Town of Kittery Maine Planning Board Meeting October 10, 2019

ITEM 1 – 60 Route 236 – Preliminary Site Plan Review

**RE: Town of Kittery, Planning Board Services
Site Plan Review
Plumbing Wholesale & Showroom (60 Route 236) Tax Map 29, Lot 14
CMA #591.126**

SITE PLAN

C1

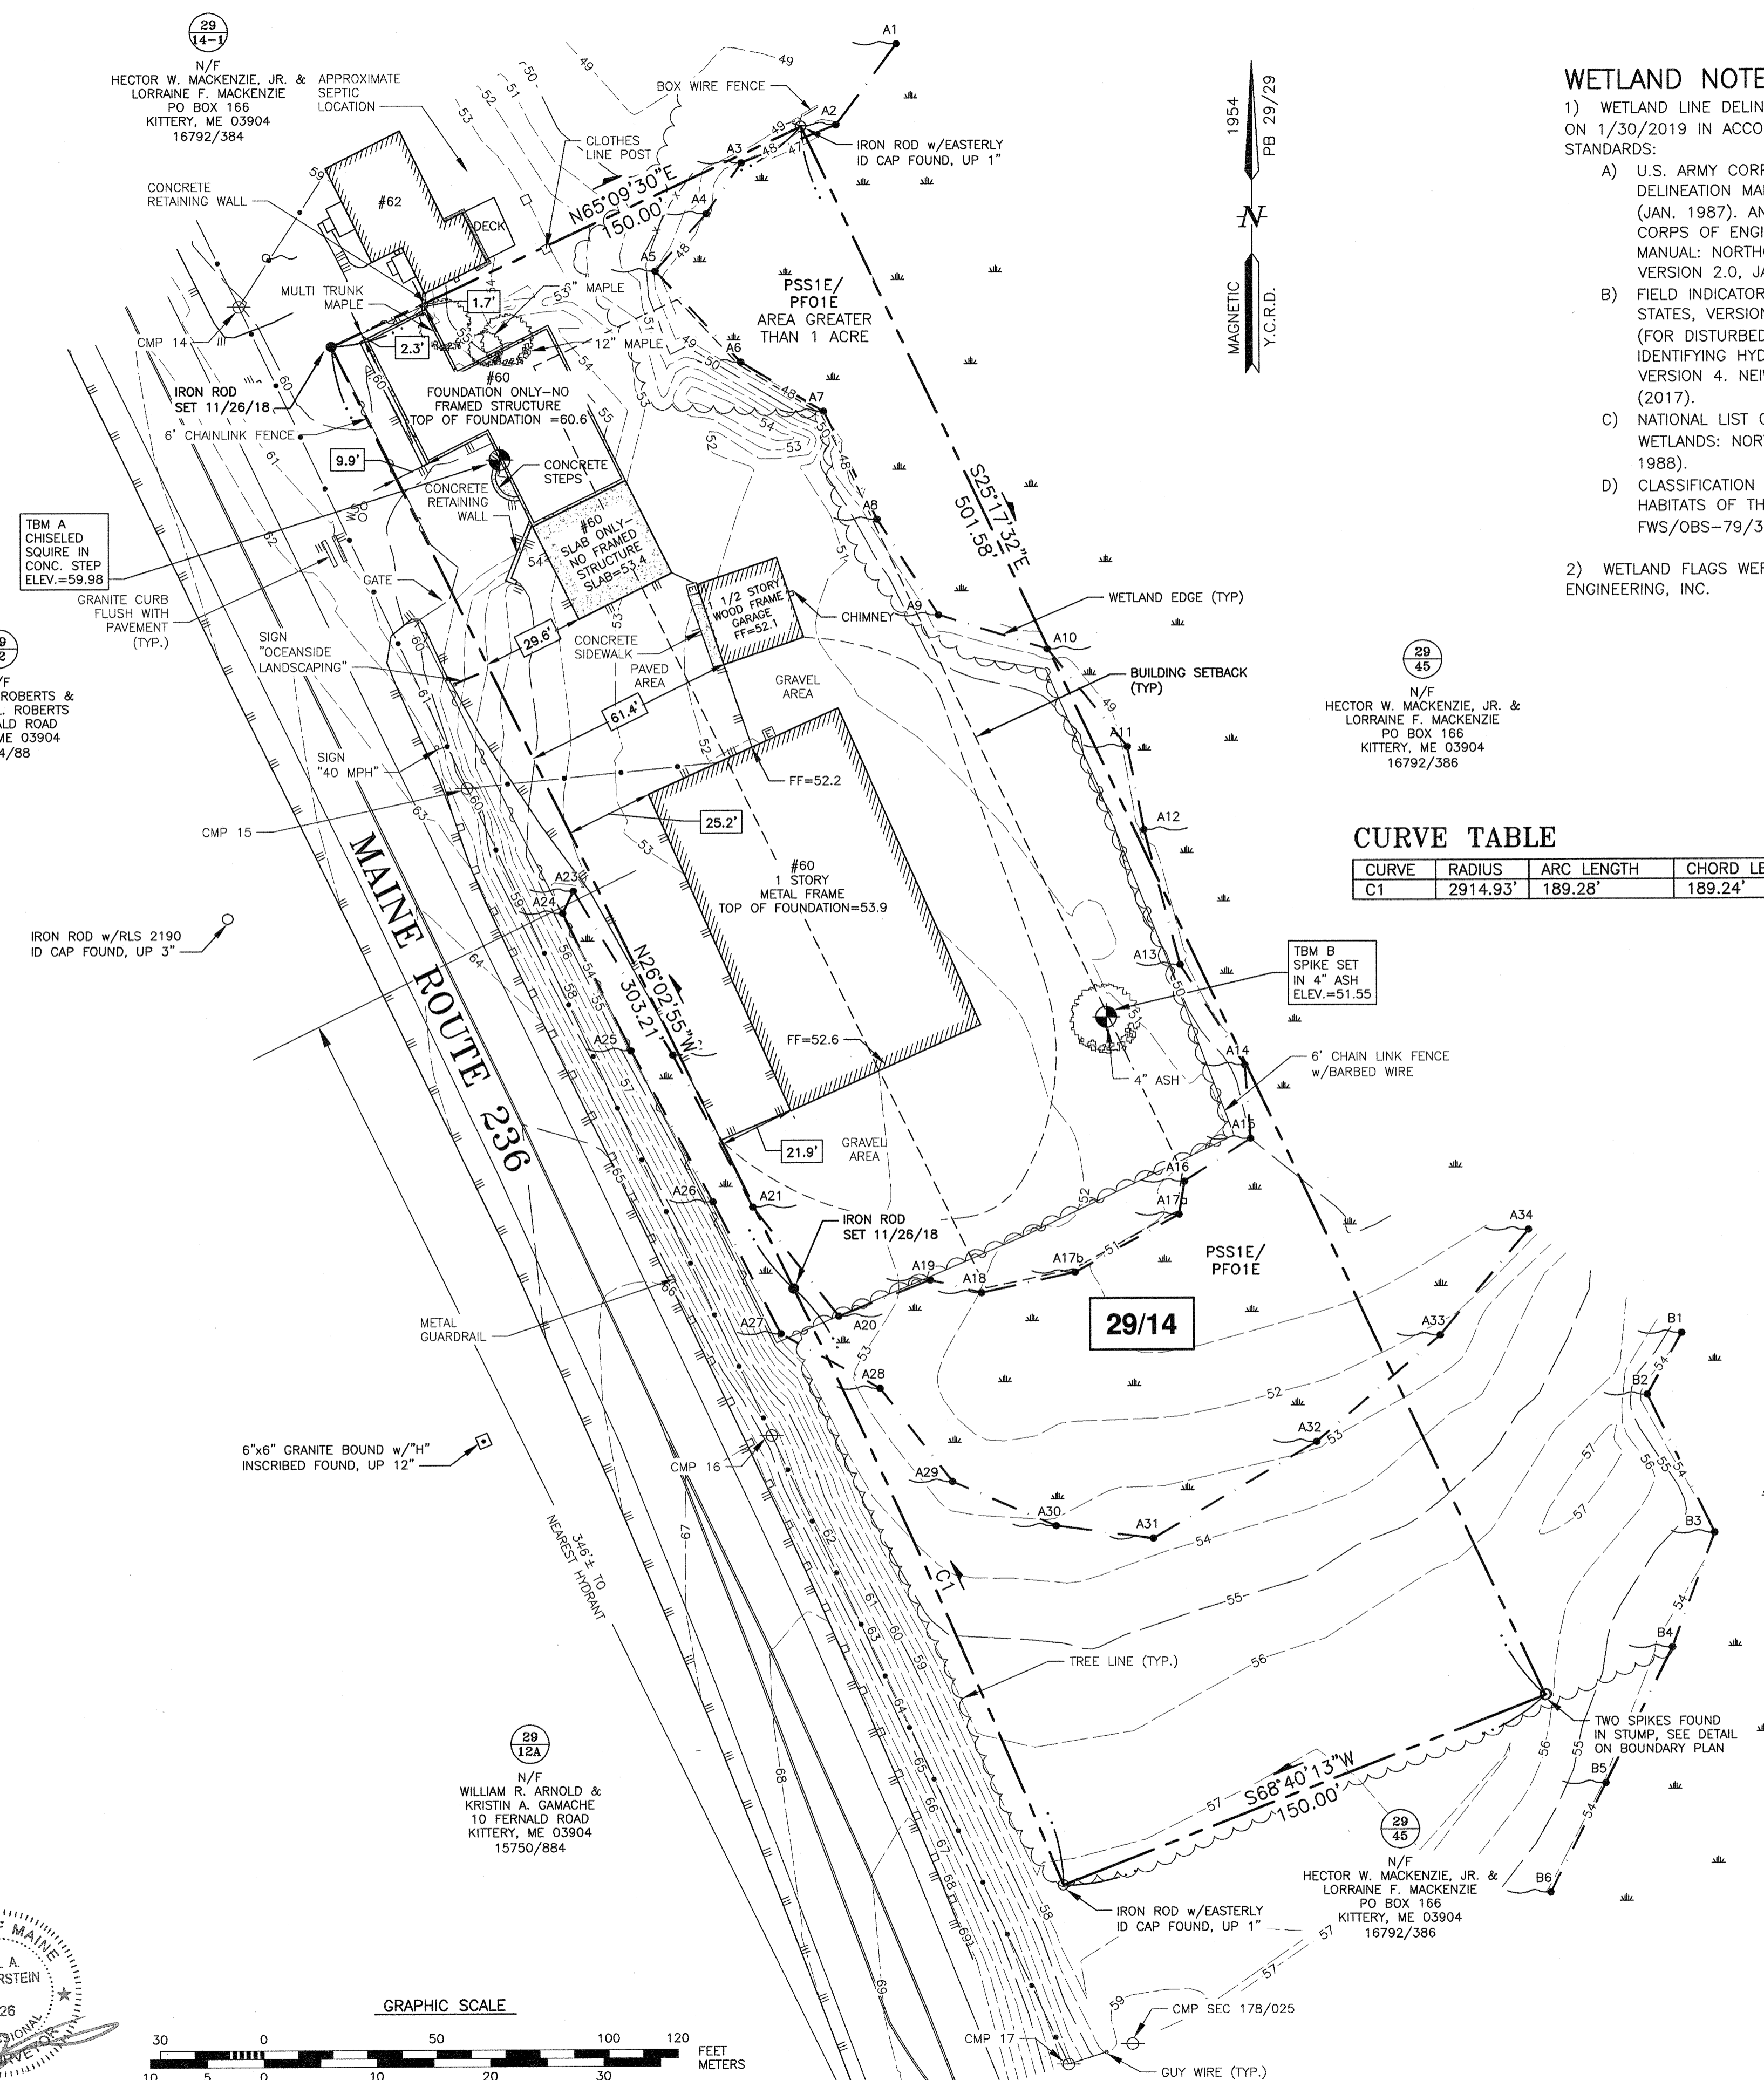
- Sheet C1 – added wetland area note, and Note 9 – observable wells within 100’;
- Sheet C3 – showing snow storage areas; and,
- Sheet D2 – revised the retaining wall detail

- 9) THERE ARE NO OBSERVABLE WELLS WITHIN 100' OF THE PROPERTY.

SITE LAYOUT PLAN
C3

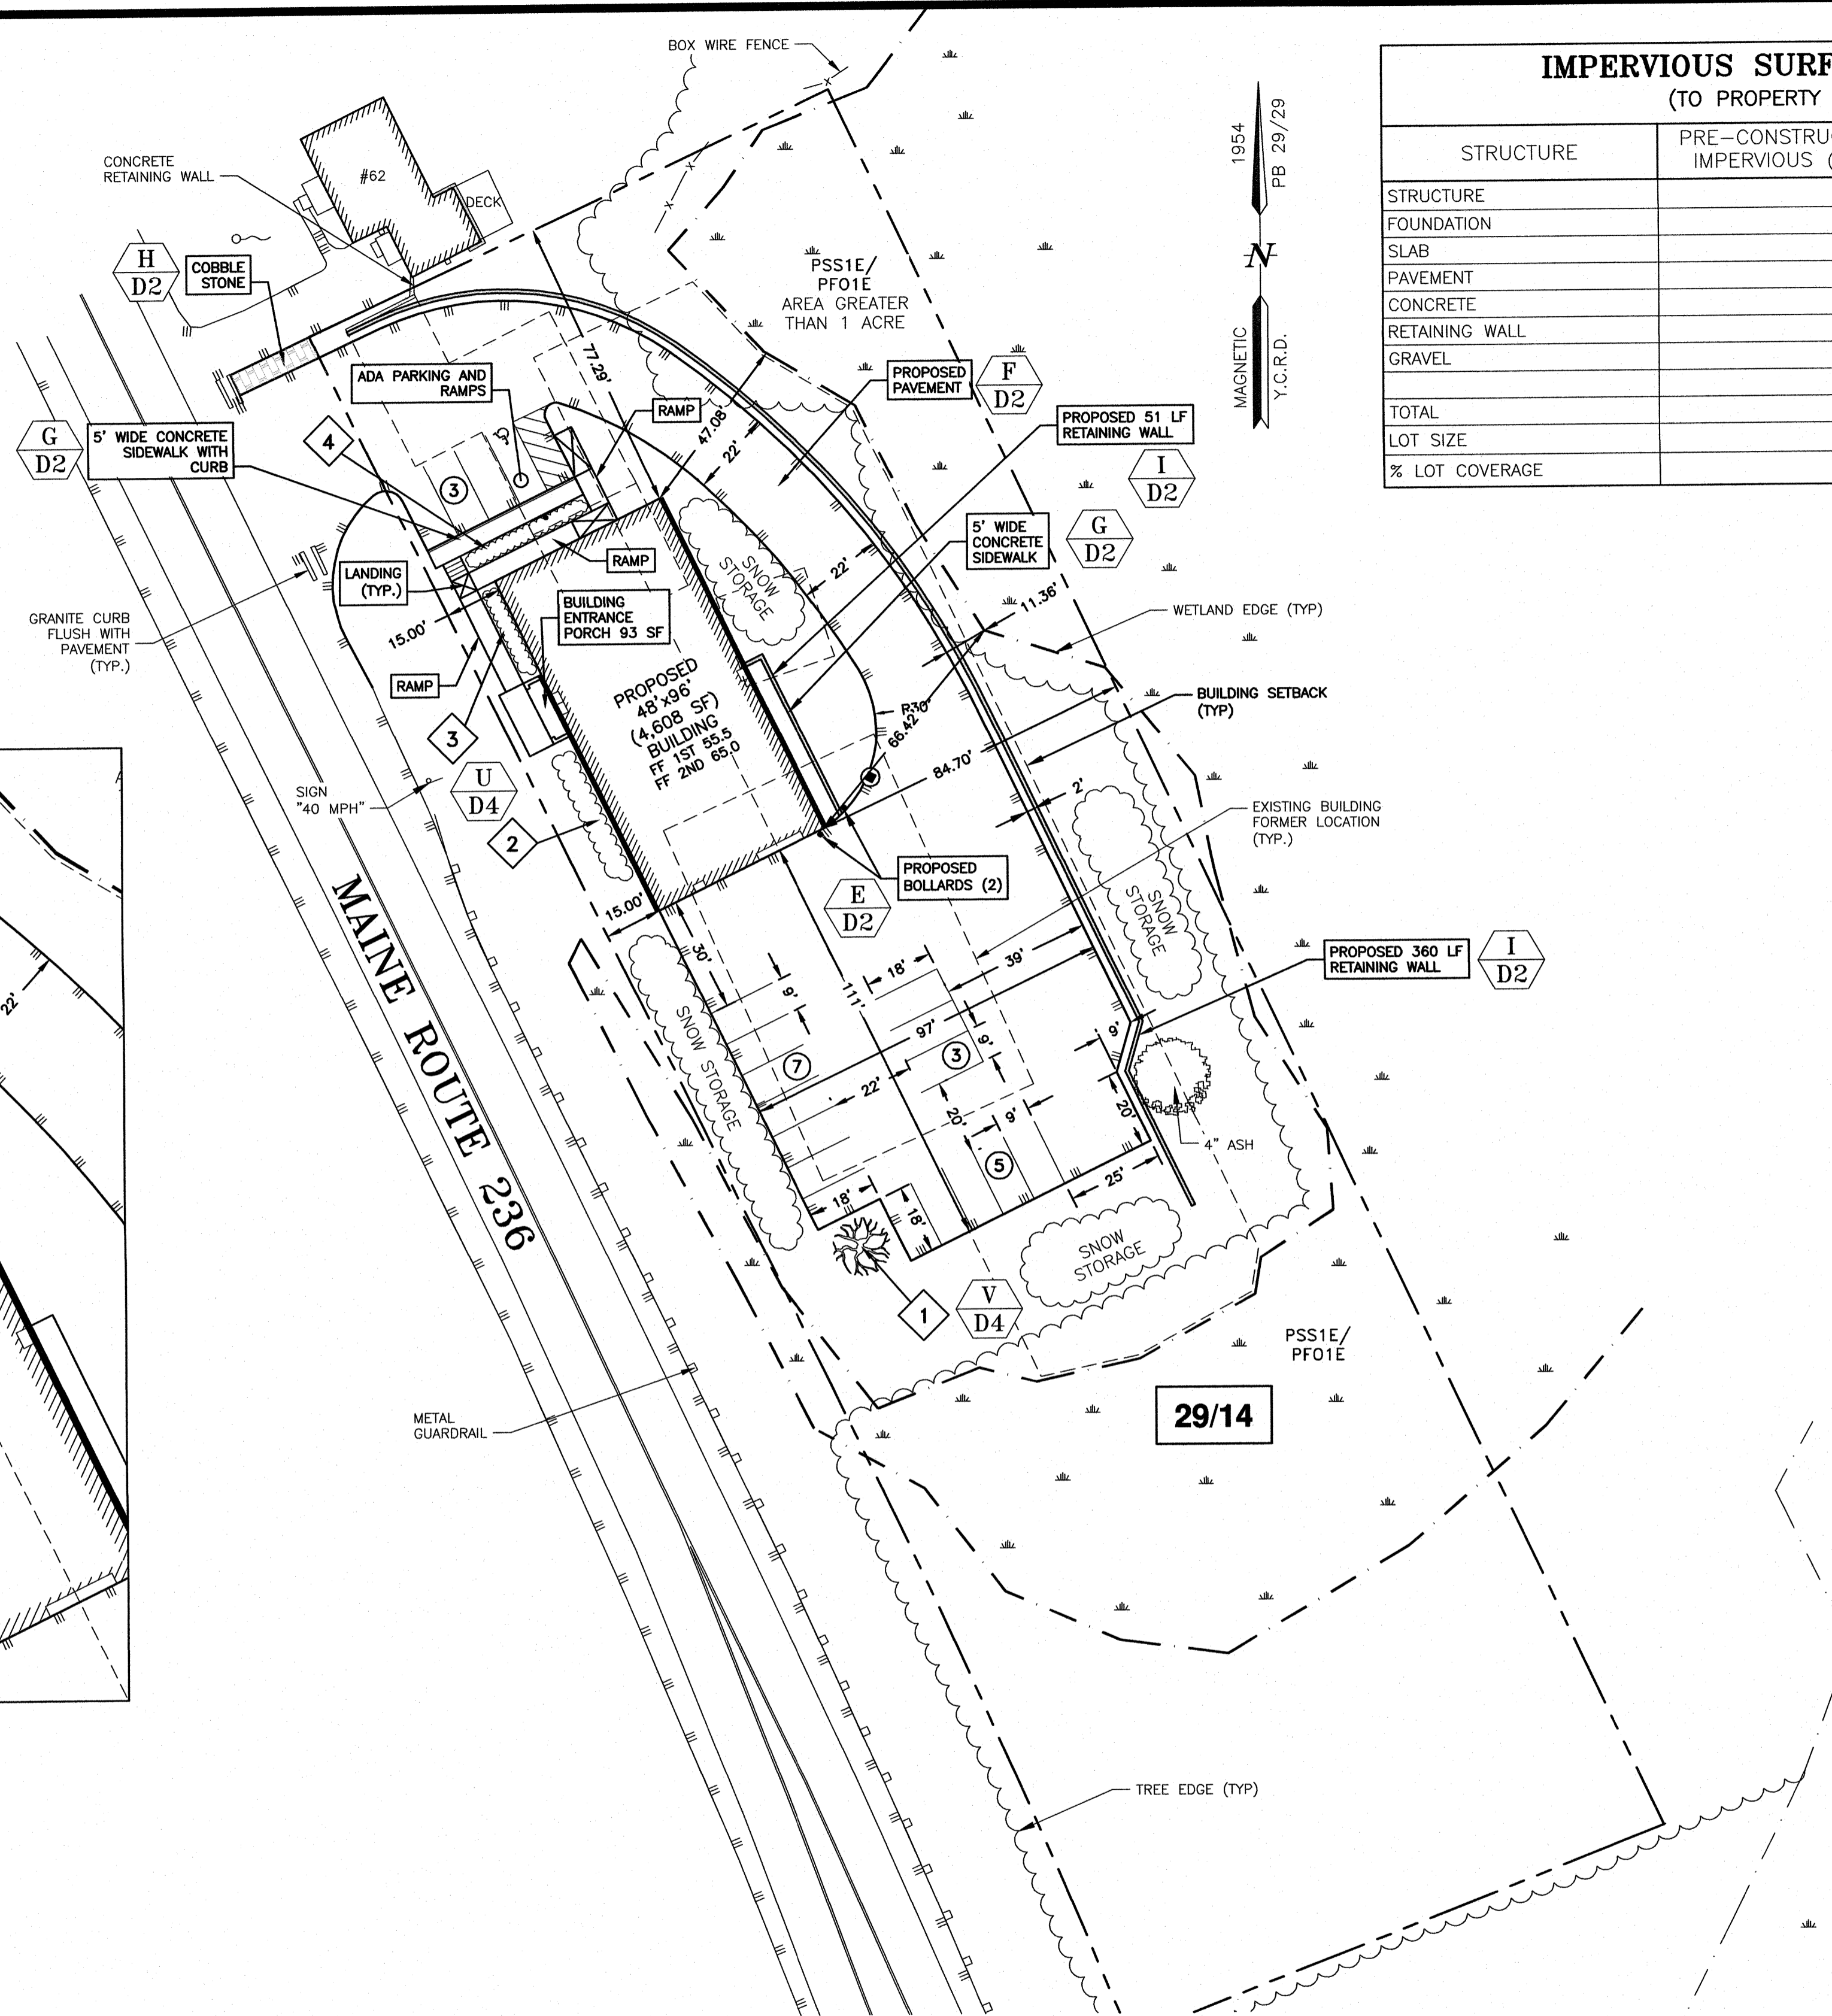
In the C-2 Zone, a vegetated landscape planter strip is required adjacent to the right-of-way of all public roads. This property would fall under the special situations provision of the Code (**16.3.2.11.D.(4) (c) [c] [ii]**) which allows the Board to narrow the depth of the planter strip. The plans call for arborvitae and yews in the fifteen (15) strip in front of the proposed building. In addition, 1 ½" caliper Red Oak is shown in the northwest corner of the proposed parking lot.

Additional plantings may be warranted to soften the appearance of the parking lot.

- 1) Revise the Site Layout Plan and Landscape Schedule to accommodate more landscape plantings for aesthetics and to effectively buffer the parking lot;*

The applicant has provided little in the way of landscaping for aesthetics and parking screening. While the site is constrained, it appears that it could support more plantings. Do the proposed landscaping elements satisfy the Board's requirements?
